11 - 2010
FD01 / FD01Z
12V DRIVER DRILL

SERVICE CHANGES

1. Changes on Switch (T/I# 90876)

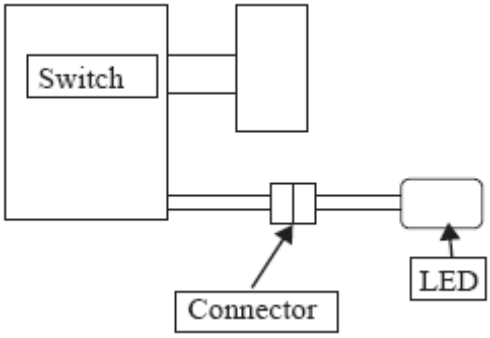
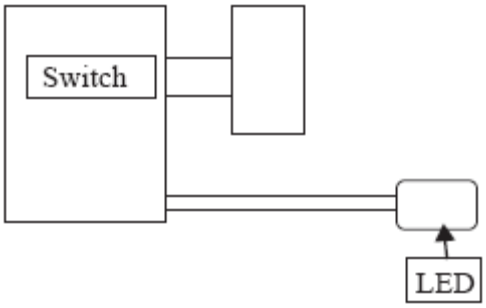
Item No.	Description	Type 1	Type 2
5	LED CIRCUIT	631813-4	-----
8	SWITCH	650599-1	650645-0

Above parts are completely interchangeable as a set.

2. Changes on Housing Set (T/I#91765) (T/I#94907)

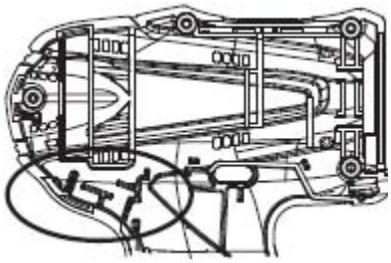
Item No.	Description	Type 1	Type 2	Type 3
2	Housing Set	188498-2	187147-8 - N/L/A	187359-3

NOTE:
For the models manufactured with Type1 (before May 2011), use Type 1 Housing set to fix Connector to the inside
For the models manufactured with Type2 or Type 3 (after May 2011), use Type 2 or Type 3 Housing set.
